Michael McGuirt - Request for Clarifications on Resource Evaluations and Impact Assessments

DOCKET
08-AFC-2

CEC REQUEST FOR CLAIRIFICATION
RESPONSE TO E-MAIL FROM M MCGUIRT DATED 3/26/09

Site BSPL-H-02. View to the south.

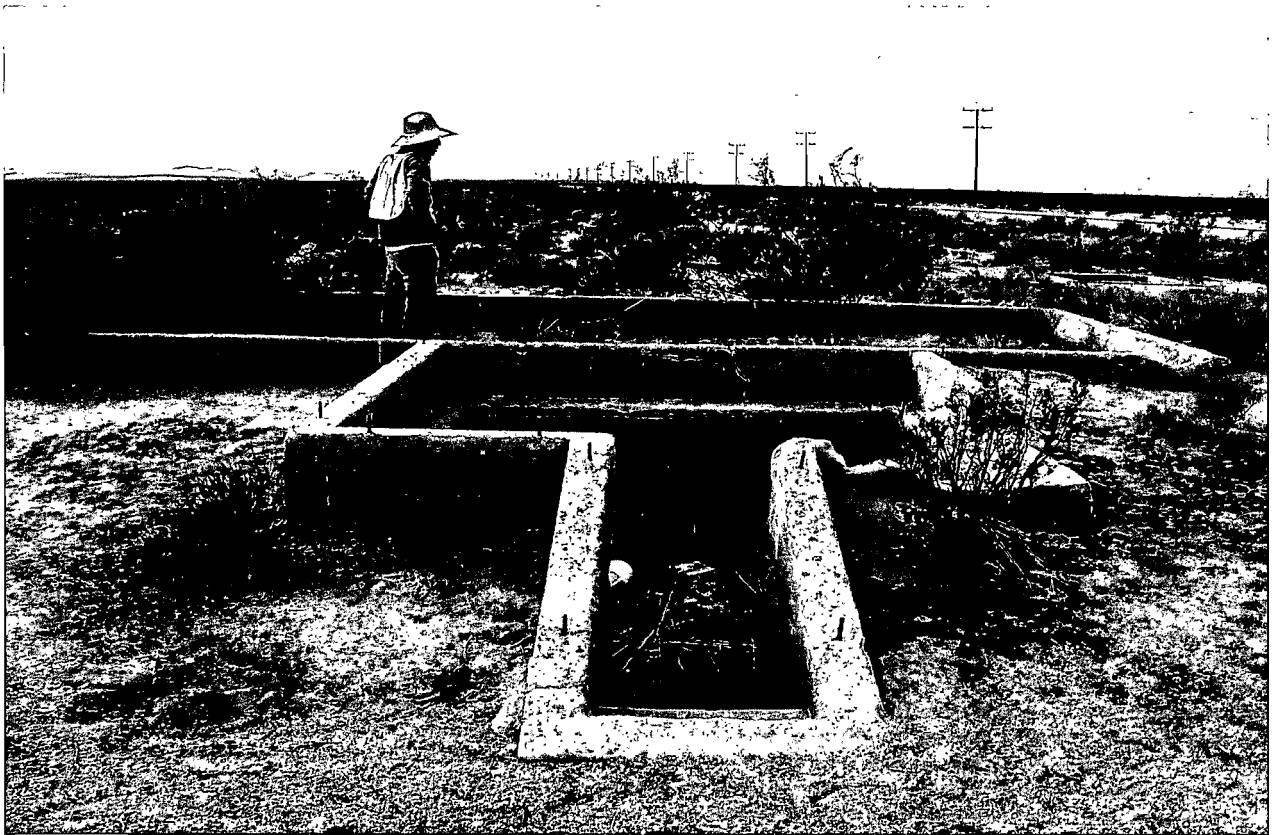
BSPL-H-02. This site appears to be approximately 20 meters east of Neuralia Road. The AFC indicates that the natural gas pipeline would be built in the ROW for that road. Is the site far enough away from the road ROW to make site avoidance feasible during pipeline construction? If FPL can commit to avoiding the site during pipeline construction, one option for the regulatory disposition of the resource would be to assume it eligible for listing in the CRHR, rather than completing the formal evaluation of the resource, and conditioning pipeline construction with explicit avoidance measures. How would FPL like to proceed here?

Response: FPL plans to confine all disturbance associated with the pipeline to Neuralia Road and the road shoulder based on cultural resource and biological concerns. Site BSPL-H-02 is several meters east of the road shoulder and the road (see below – Neuralia Road is visible in the upper right portion of the photograph). FPL will commit to avoiding the site BSPL-H-02.
